# UNITED STATES PATENT AND TRADEMARK OFFICE

APPLICATION NO.	FILING DATE	FIRST NAMED INVENTOR	ATTORNEY DOCKET NO.	CONFIRMATION NO.
10/568,283	09/14/2006	Masanori Wada	2006-0184A	3298
513 7590 03/21/2007 WENDEROTH, LIND & PONACK, L.L.P. 2033 K STREET N. W. SUITE 800 WASHINGTON, DC 20006-1021			EXAMINER ROJAS, OMAR R	
			ART UNIT 2874	PAPER NUMBER
SHORTENED STATUTORY PERIOD OF RESPONSE			MAIL DATE	DELIVERY MODE
3 MONTHS			03/21/2007	PAPER

**Office Action Summary**

wherein both the outer peripheral face of the stub 3 and the inner hole of the precision sleeve 5 have a surface roughness Ra value of 0.2 micrometers or less (Document AJ: page 7, paragraph [0036]). Figure 1 of Morooka is reproduced below.

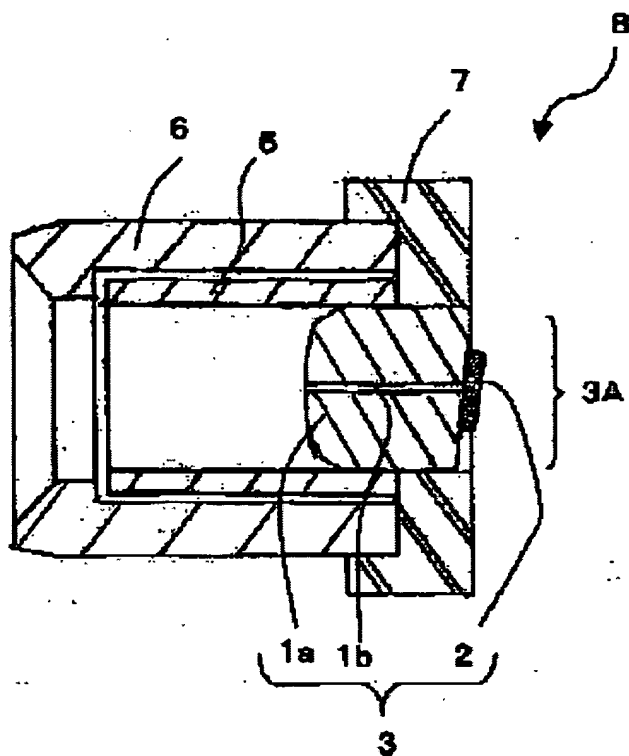
*In re* claim 1, Morooka discloses an optical receptacle (Figures 1-3) comprising:

a precision sleeve 5;

a stub 3 with an optical fiber 1b fixed to one end of an inner hole of the precision sleeve 5 through an adhesive (Document AJ: page 6, paragraphs [0022] & [0026]);

and a sleeve holder 6/7 fixed to an outer periphery of the precision sleeve 5 by press-fitting or through an adhesive (Document AJ: page 4, paragraph [0004] and page 7, [0043]);

*In re* claim 4, Morooka discloses a bore tolerance between the sleeve 5 and the ferrule 1a of 1 micrometers or less (Document AJ: page 7, paragraph [0036]).

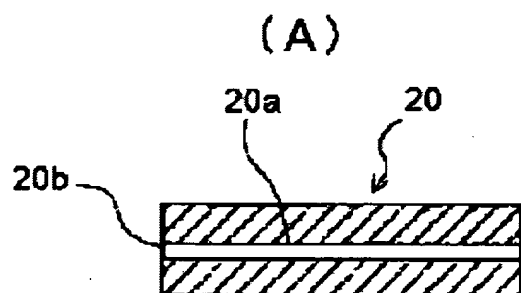
*In re* claims 2 and 10, Morooka only differs from the claims in that Morooka does not expressly teach that the outer periphery of his stub 3 or the inner hole of his precision sleeve 5 has a surface roughness Ra value of more than 0.2  $\mu\text{m}$  and a surface roughness Ry value of 4.0  $\mu\text{m}$  or

less, and a difference between an average line and a peak line of surface roughness is 2.0  $\mu\text{m}$  or less. Saito, however, teaches an inner hole 20a of a capillary tube 20 having values of a surface roughness  $R_a$ , a surface roughness  $R_y$ , and a difference between an average line and a peak line of surface roughness that overlap the values recited by claim 2. *See* Document AI, page 10, paragraph [0040]. Figure 1 of Saito is reproduced below.

Although Saito is primarily concerned with the alignment between his capillary tube 20 and an optical fiber, the same physical principles would have also applied to aligning Morooka's precision sleeve 5 and ferrule 1a. In other words, one of ordinary skill in the art would have easily recognized that solutions for optimizing alignment between a cylindrical optical fiber and a cylindrical tube (Saito) would also apply to aligning a cylindrical ferrule with a cylindrical sleeve (Morooka). The motivation for combining Saito with Morooka would have been to optimize alignment between the sleeve 5 and ferrule 1a of Morooka by applying similar techniques to those used by Saito to align his optical fiber and capillary tube. Therefore, it would have been obvious to one of ordinary skill in the art at the time of the claimed invention to obtain the invention specified by claims 2 and 10 in view of Morooka combined with Saito.
